Work Order ID 84263

Item Name: Crosstube Aft

<b>DART AEROSPACE LTD</b>		<b>Work Order:</b>	84263
<b>Description:</b> Crosstube High Aft (205/212)		<b>Part Number:</b>	D212-664-201
<b>Inspection Dwg:</b> D212-664-241 <b>Rev:</b> D			<b>Page 1 of 1</b>

# DART SERVICE INSTRUCTION

**FIGURE 1: SUPPORT INSTALLATION**

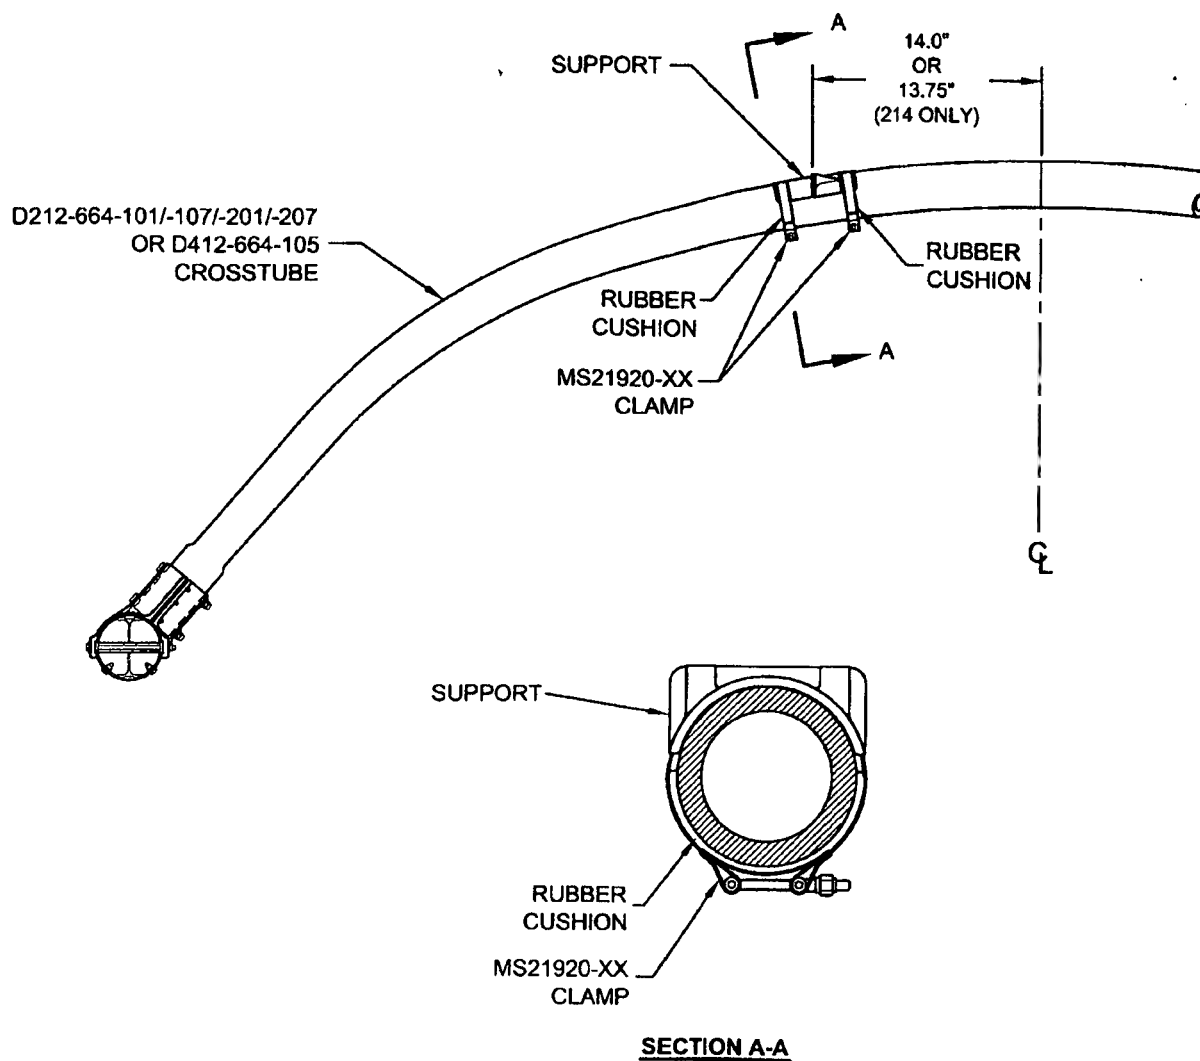
The supports on the following crosstubes are now installed using Proseal instead of Magnobond:

For the crosstubes listed above, section 32.4 of ICA-D212-664 is amended as follows. Use Figure 1 of this service instruction and Figures 32-2 to 32-9 of ICA-D212-664 for further reference. For crosstubes of an earlier change number, it is recommended that if the supports are removed, the supports should be reinstalled using the procedure listed below.

- 32.4.5 Apply a 0.04" to 0.07" thick layer of Proseal 890 Class B or AMS-S-8802 Class B sealant underneath applicable support and install support as shown in Figure 1 of this service instruction.

- 32.4.6 Install the clamps opposite to crosstube support as shown in section A-A of Figure 1. Install rubber cushions underneath each clamp around the bottom circumference of the crosstube up to the crosstube centerline. Torque clamps 80-100 in-lb (9.0-11.3 Nm). It is acceptable to use smaller or larger sized MS21920-XX clamps than those listed in ICA-D212-664, ensure that after torquing the clamps per this instruction, the nuts are in safety but not bottomed out

D212-664-241/-241B  
 ASSEMBLY DETAIL D

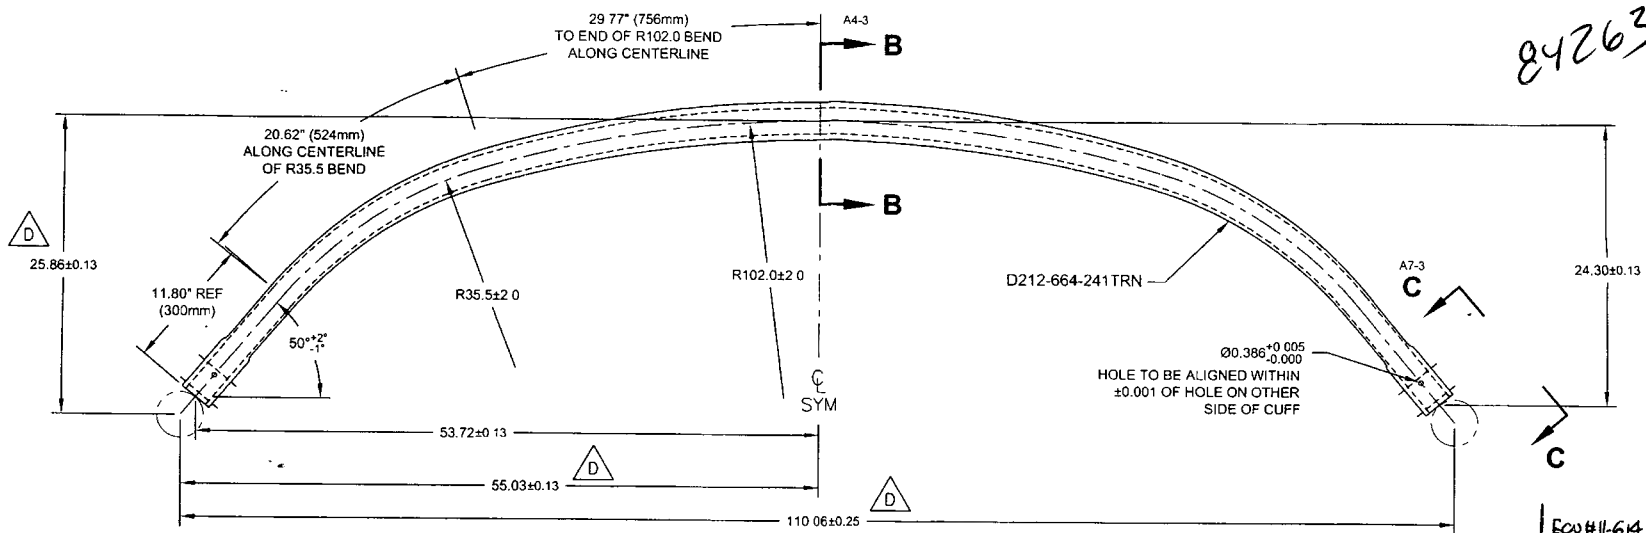
12  
 APPLY MAGNOBOND  
 BETWEEN D2940-1 AND  
 CROSSTUBE

REPLACE MAGNOBOND WITH PROSEAL.

- 12) TO INSTALL D2940-1 SUPPORT: ABRASE MATING SURFACE OF SUPPORT AND CROSSTUBE WITH 180-GRIT SANDPAPER AND REMOVE RESIDUE WITH MEK (OR EQUIVALENT). APPLY A 0.04" TO 0.07" THICK LAYER OF PROSEAL 890 CLASS B-2 (OR AMS-S-8802 CLASS B-2) SEALANT TO MATING SURFACE OF SUPPORT.
- 15) TORQUE CLAMPS 80 TO 100 IN-LB. ENSURE AT LEAST 1.5 THREADS SHOWING IN SAFETY AND THAT NUT HAS NOT BOTTOMED-OUT AFTER TORQUING. **PRIOR TO PACKAGING, RE-CHECK TORQUE ON CLAMPS AFTER PROSEAL 890 SEALANT HAS CURED FOR 72 HOURS.**
